UNITED STATES PATENT AND TRADEMARK OFFICE

APPLICATION NO.	FILING DATE	FIRST NAMED INVENTOR	ATTORNEY DOCKET NO.	CONFIRMATION NO.
10/720,278	11/25/2003	Alain Poiraud	2937-115	4789

Office Action Summary

DETAILED ACTION***Information Disclosure Statement***

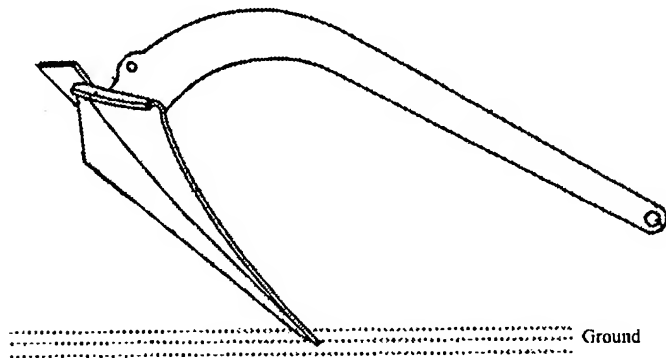
10. Claims 1, 5, 9 and 10 are rejected under 35 U.S.C. 102(b) as being anticipated by Goodman (US 6,390,011 B1).

Re claim 1, Goodman shows a boat anchor [10] (figures 1 and 2), having a fluke [15,16] with a tip [17] and a back with a curved rear edge [18], and a shank [11] mounted on the fluke. The shank has a curved edge, and an opening [14] at an end opposite the fluke. The opening is offset from a plane tangent to the back edge of the fluke and to the edge of the shank. When considered in a side elevation view (see fig. 2), the anchor is considered asymmetric with respect to a horizontal plane passing the shank.

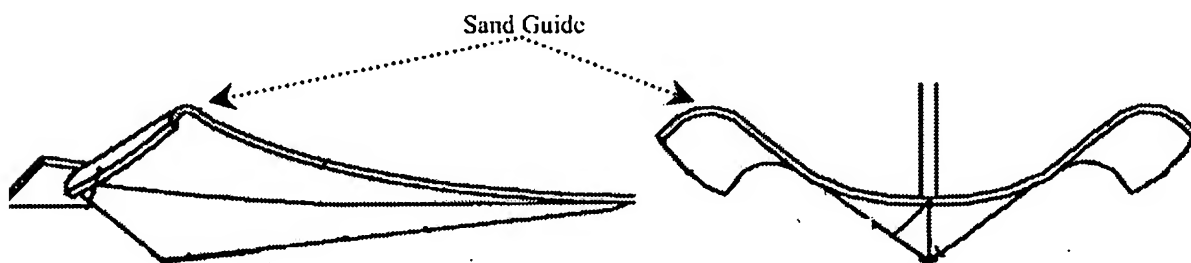
Re claim 5, if the anchor is tipped in an orientation shown below, most of the weight of the anchor will be borne by the tip of the anchor. In such orientation, the proportion of the weight of the anchor on the tip would higher than 20%.

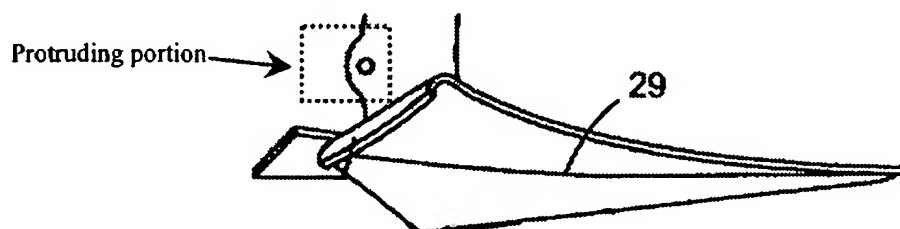
Re claim 9, the sloped upper surface of the back upper side is considered equivalent to a sand guide because when the anchor is dragged through the sand, the sloped surface would allow the sand to be guided over and behind the anchor.

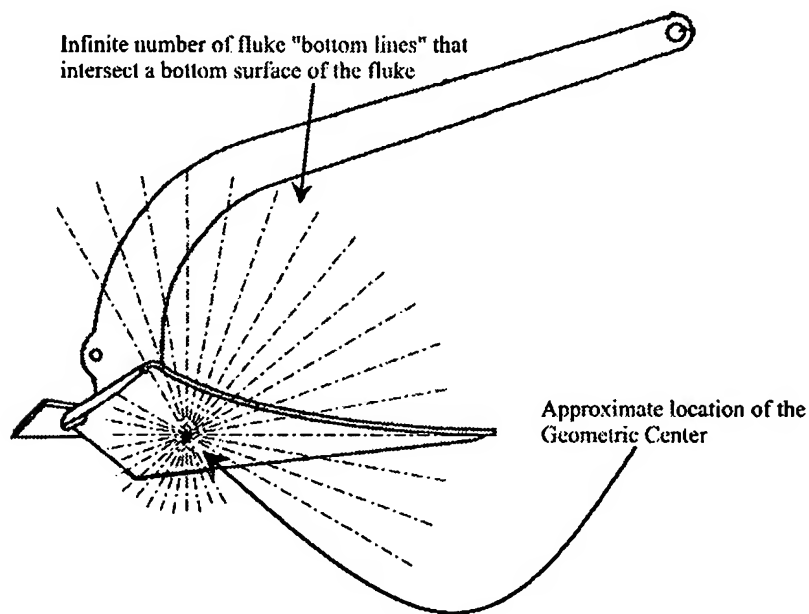
Peabody ('456) shows an anchor having second openings [18B, 18C] in proximity to a first opening [18A] of an arcuate shank (fig. 3). The second openings allow for a variation in the fluke's effective angle of attack, thereby enabling the most effective anchor penetration (fig. 3, and col. 1, lines 8-10, lines 18-24; and col. 2, lines 4-8).

It would have been obvious for one skilled in the art at the time of the invention to provide second openings in the shank of Goodman, as taught by Peabody, such that the second openings were disposed in proximity to the first opening. Having such second openings would have allowed one to vary the fluke's effective angle of attack, thereby allowing the anchor to be used effectively in different types of marine beds.
